Totmonslow Solar Farm

Summary of Changes Made to the Proposed Development

Applicant: RE Projects Development Ltd

April 2023

Figure 4 - Updated Mitigation and Enhancement Plan (1107_12 Rev 5) which replaces 1107_12 Rev 4

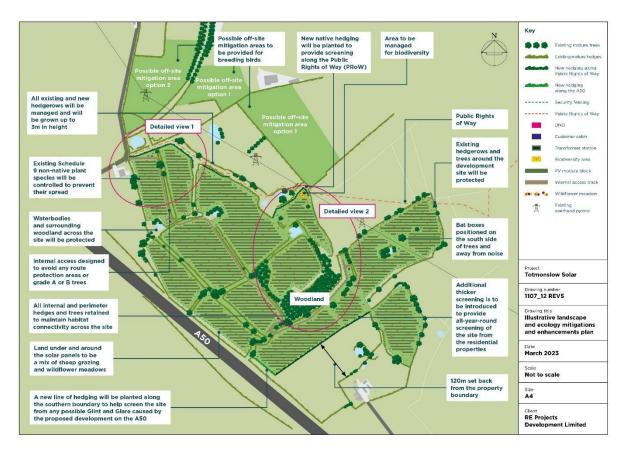
- Off-site mitigation area was proposed for breeding birds as shown in Figure 4, which may be used if the ongoing breeding bird surveys confirm the need.

The submitted Illustrative Landscape and Ecological Mitigation Plan (1107_12 Rev 5) shows possible off-site mitigation areas for breeding birds. The applicant's ecologist Enzygo is undertaking 6 breeding bird surveys:
	 The first was undertaken on 20th March 2023 – which revealed a common and typical assemblage of farmland conditions with the majority of species restricted to field boundaries. Notably, there were no ground-nesting farmland species such as Skylark, Lapwing or Yellow Wagtail. The remaining surveys will be undertaken between April and June 2023. As agreed with the LPA's ecological advisor in draft planning
	conditions 5 and 6 of the refused application, the some or all of
